HISTORIC DISTRICT REVIEW BOARD MEETING AGENDA

MEMORANDUM

Subject: Discussion Item, 781 Station Street, Herndon Virginia

This staff memo addresses a discussion item brought to the Board by a future applicant wishing to obtain feedback and direction from the Board prior to submitting an official application. The project is the construction of an addition to the second-story front façade of a building at 781 Station Street. The 1987 survey of historic properties lists this as a contributing structure in the Historic District, built between 1920 and 1940. The Town's online HDO map also identifies it as contributing.

1 EXISTING - FRONT ELEVATION
1/4" = 1'-0"

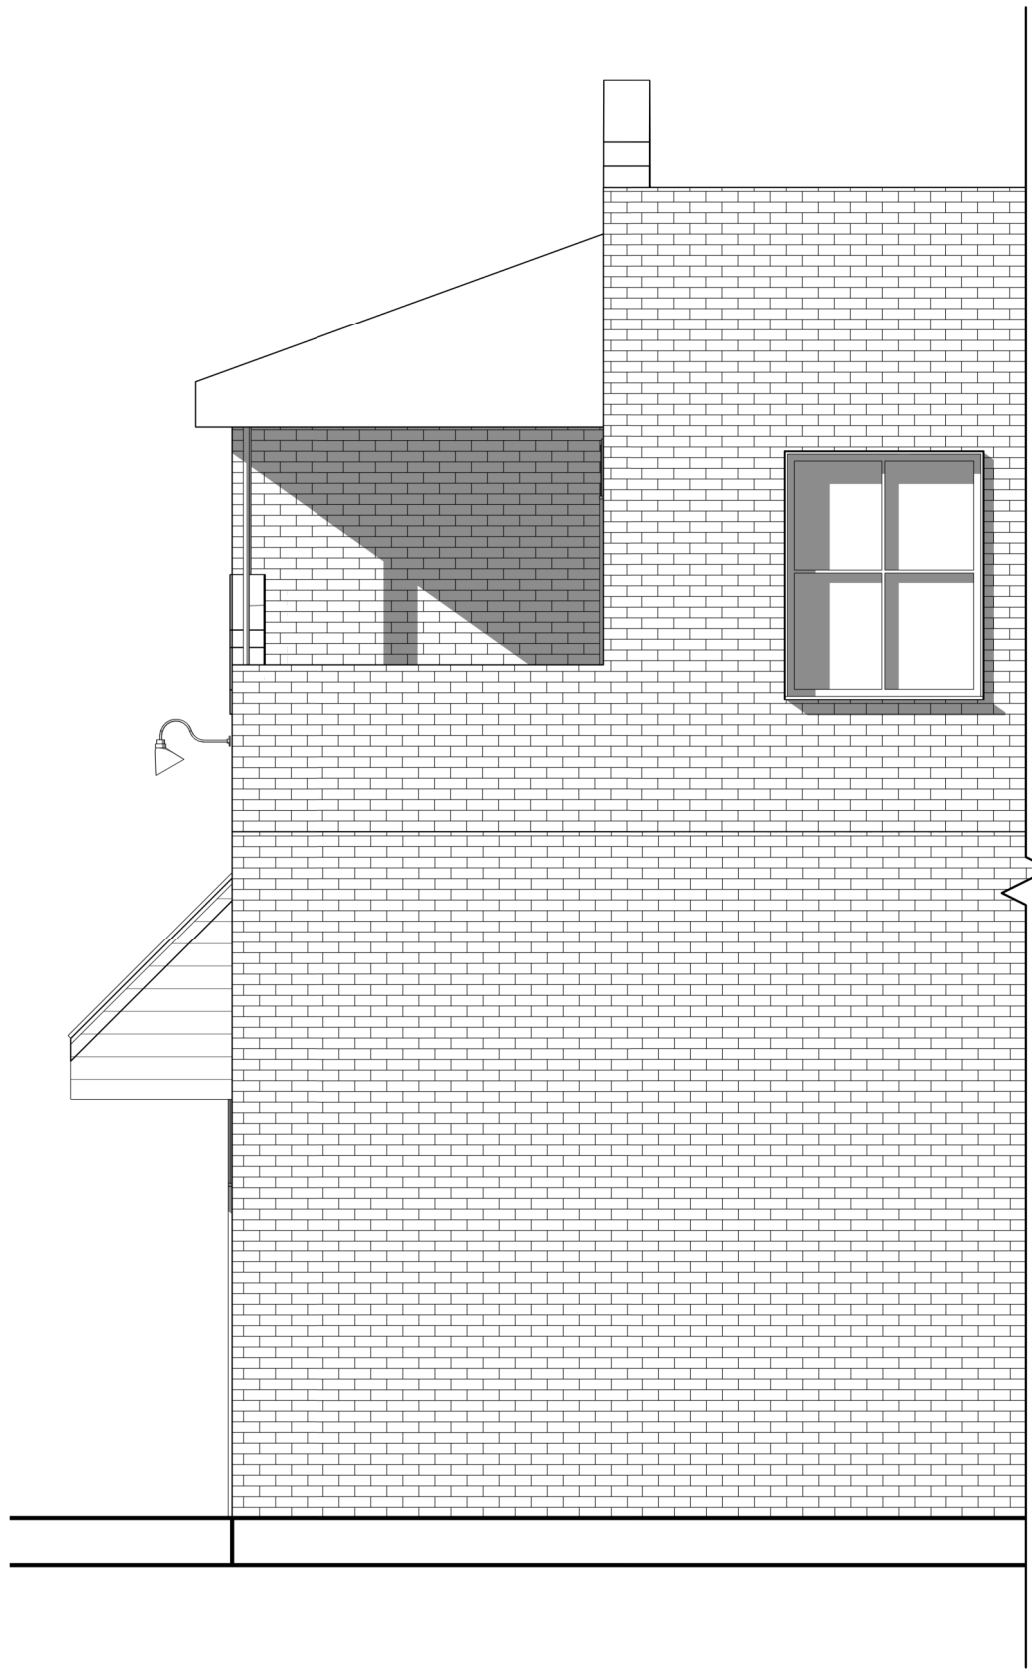
Window compatibility. The submitted drawings appear to have been chosen in an effort to retain some of the transparency that exists with an open-air-covered balcony. If this is the aim, more details should be provided in an official application describing the transparency/non-reflectiveness of the glass. As with all windows within the Historic District, details regarding material, design, and other specifications make a significant difference in approvability.

Scale and subordination to existing building. The second section from the Guidelines quoted above discusses the need for an addition to be secondary to the primary structure in size and position, and that an addition should not change the overall scale and massing of a building. For second-story additions this is especially important: *“Second-story additions on historic buildings are generally not appropriate unless the addition is designed in such a way that it does not impact the massing, scale, and character of the historic building.”* The current modern addition to the historic structure was approved in 1995 as referenced above. A key element of this approval was that the second story was set back from the primary building. The proposed addition would negate the earlier effort to maintain the character of the historic structure and would significantly alter the appearance, character, and integrity of the historic form, mass, and parapet detail. Staff believes that as proposed, the addition changes the scale of the building by adding a second story that is flush with the first floor, negating the current stepped back façade, and that it changes the character of the building by introducing a prominent modern second story.

Additional notes. The argument could be made that as existing, there is essentially a second story with the awning over the second story balcony, and that fully enclosing this space with an addition would not change the current scale and massing. While the canopy does introduce a roof and outlines a second-story area, currently the area is permeable, transparent through to the stepped back façade, and is temporary in nature. Permanently enclosing the area as proposed would significantly change the massing and perceived scale of the building and undermine the character of this façade which faces a prominent streetscape within the Historic District. Given the significant change in the character of the building and the Guidelines that address such changes, it is unlikely staff would recommend approval of a formal application for this addition as proposed.

781 AND 783 STATION STREET ELEVATION

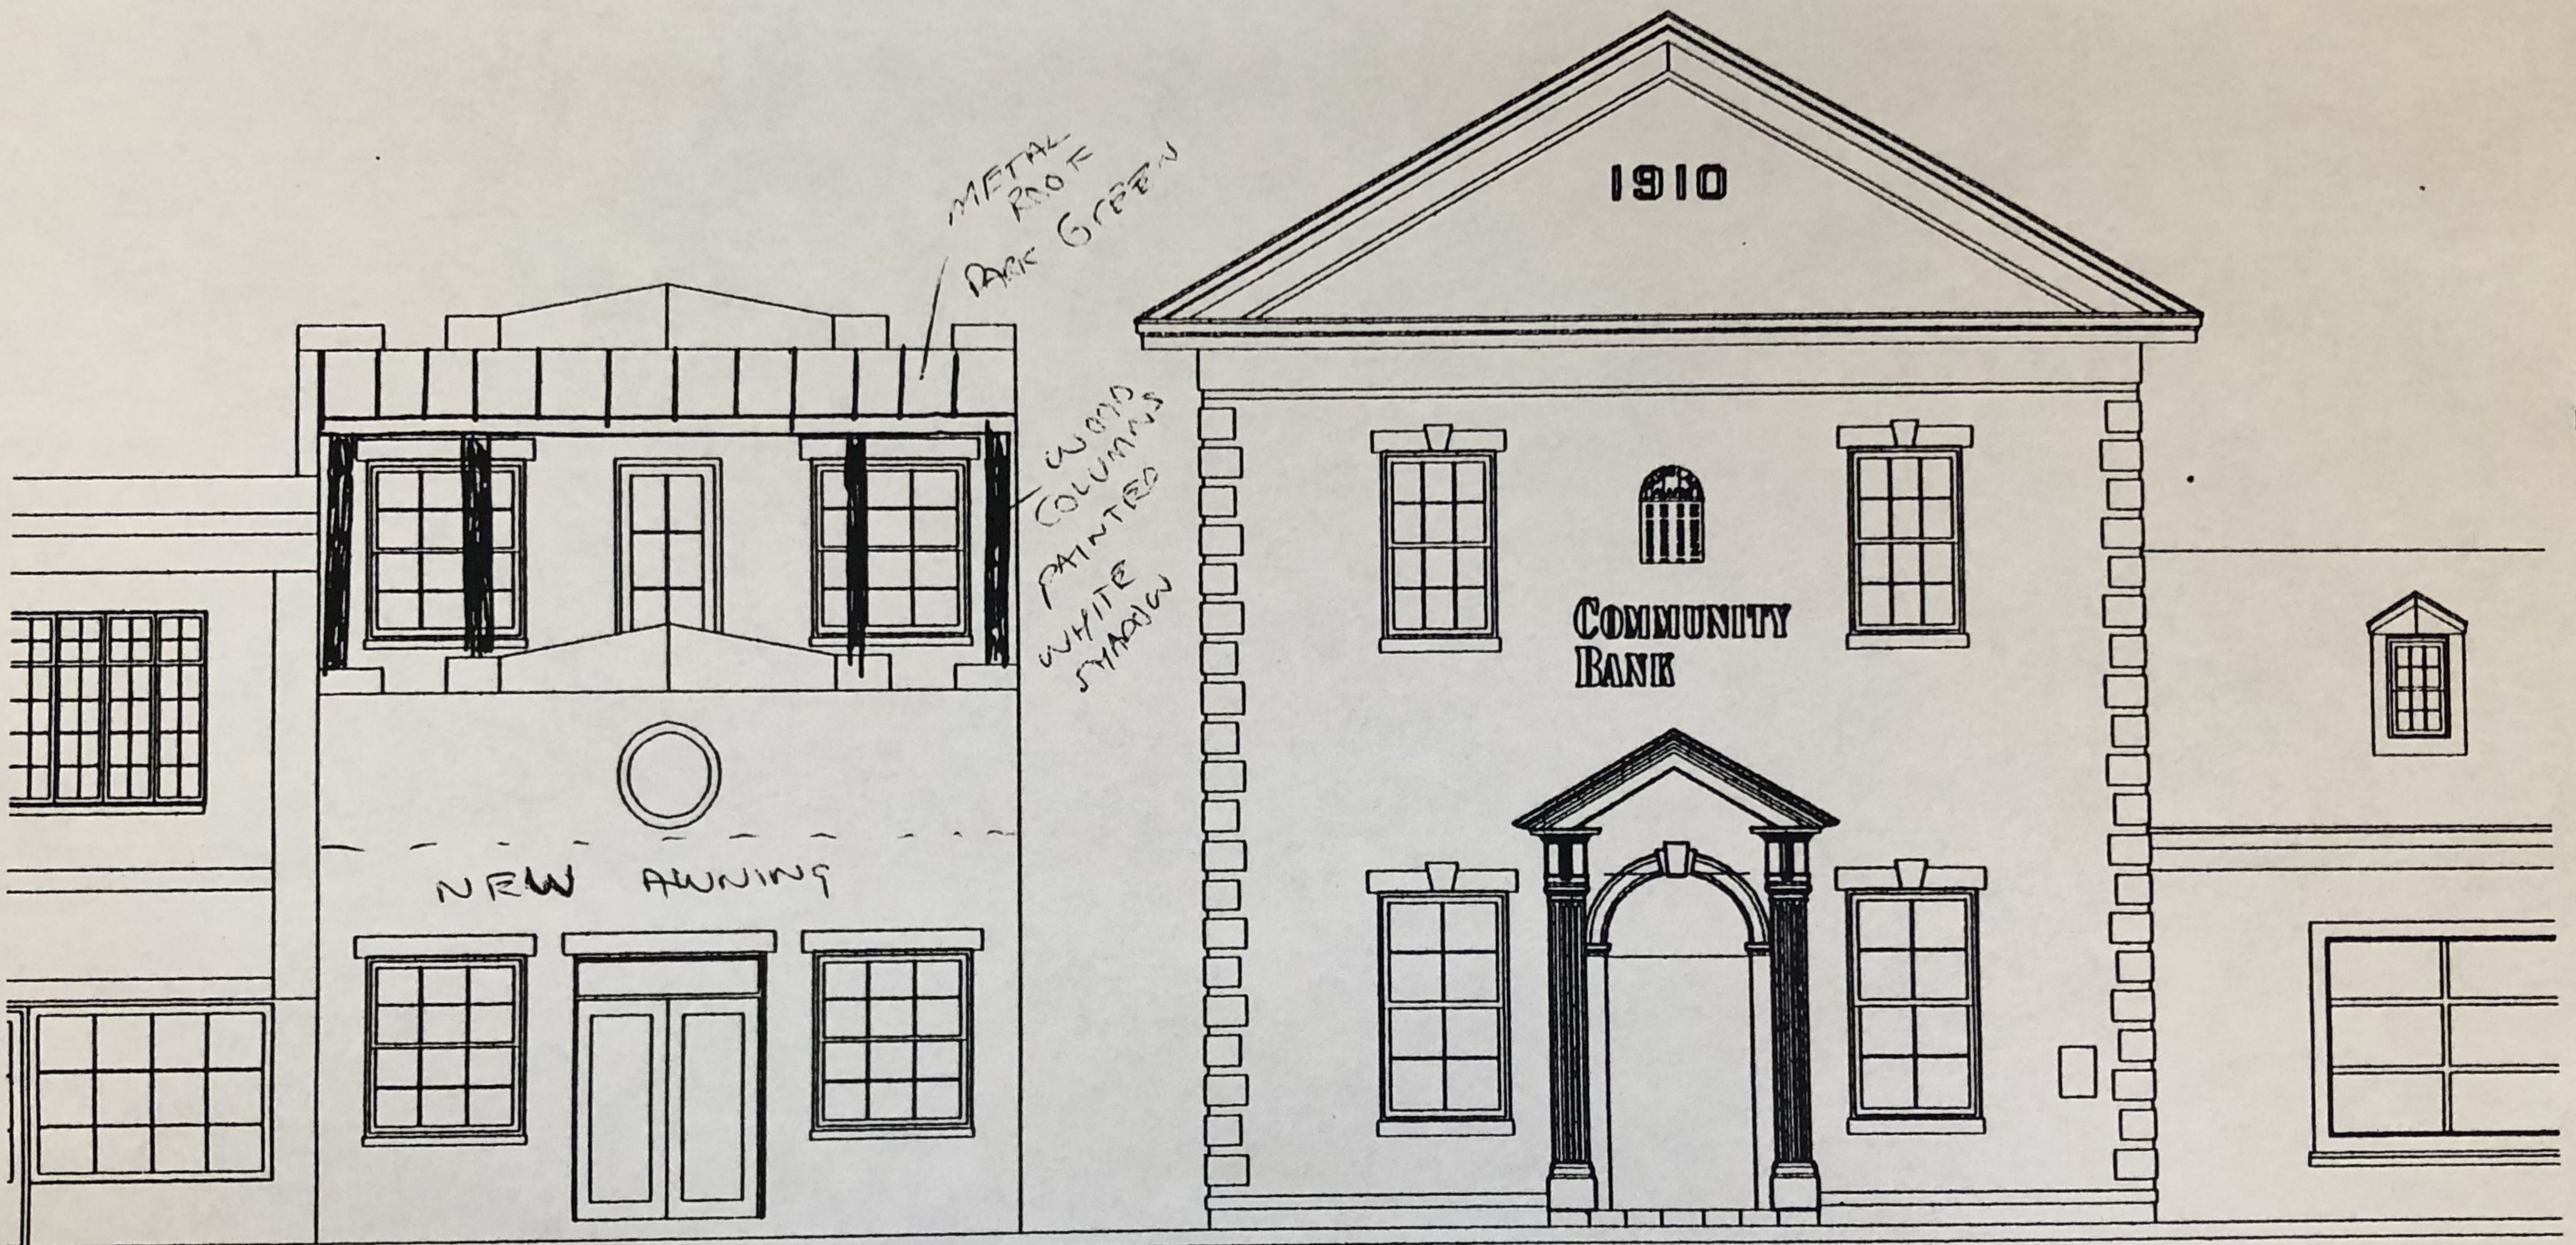
STAFF COMMENTS: Heritage Preservation Review Board staff suggests that covering the balconies could be an attractive option if designed very carefully. Staff believes that a copper standing seam metal roof is an appropriate roofing material in the Heritage Preservation District. Staff suggests that copper half-round gutters would be more appropriate running along the front elevation than white gutters. Staff realizes that white scuppers and gutters are utilized on the sides of the existing structure, but staff believes that copper gutters would be more appropriate and attractive immediately adjacent to the copper roof.

Staff is also concerned about the size and shape of the columns. Staff believes that the columns must be carefully designed and proportioned to make this a successful alteration. Staff suggests that the columns should not be white or off-white, as this will draw additional attention to them. Staff suggests that the columns be painted the dark teal of the storefront. Furthermore, staff suggests that the interior roof should be attractively finished and painted or stained since it will be visible. Staff also believes that the applicant's statement concerning the sides of the porch needs clarification.

The Herndon Heritage Preservation Handbook states that curved awnings may be appropriate for noncontributing or new commercial buildings. The subject of this application, 781 Station Street, is an historic contributing structure. Staff suggests that if any awning is mounted on the building, it

should be a fixed sloped awning. Furthermore, staff suggests that the awning should not extend across the entire facade, but should extend only above the doors and windows. Furthermore, staff believes that the flat marquee should be peaked to correspond to the fixed slope awning, shed roof of the balcony and the gable of the stepped parapet.

The size and depth of the awning should be selected based upon the width of the sidewalk, the structure's architectural elements, and adequate head clearance. Staff suggests that the applicant should investigate awning materials to determine if the canvas is coated. The Handbook states that shiny fabrics are not appropriate. It is staff's understanding that coated canvas and even vinyl fabrics are available in a matte finish. Staff also suggests that rather than the standard hunter green, the awning should match the storefront trim. The existing sign is hunter green and clashes with the teal window and door frames. Furthermore, staff suggests that the applicant state for the record any proposed methods of illumination.

1. The posts supporting the shed roof will be 4x4 posts with a base and cap as demonstrated this evening;
2. The shed roof will be metal in Colonial Red and will have a 2:1 pitch;
3. The top of the shed roof adjacent to the building will extend to a point permitting 2 courses of brick to be exposed above the shed roof and below the key-way;
4. The shed roof will be approximately 4 inches off each end of the building;
5. The ceiling of the shed roof shall be finished, painted and shall include ceiling fans;
6. The proposed gutters shall be white.
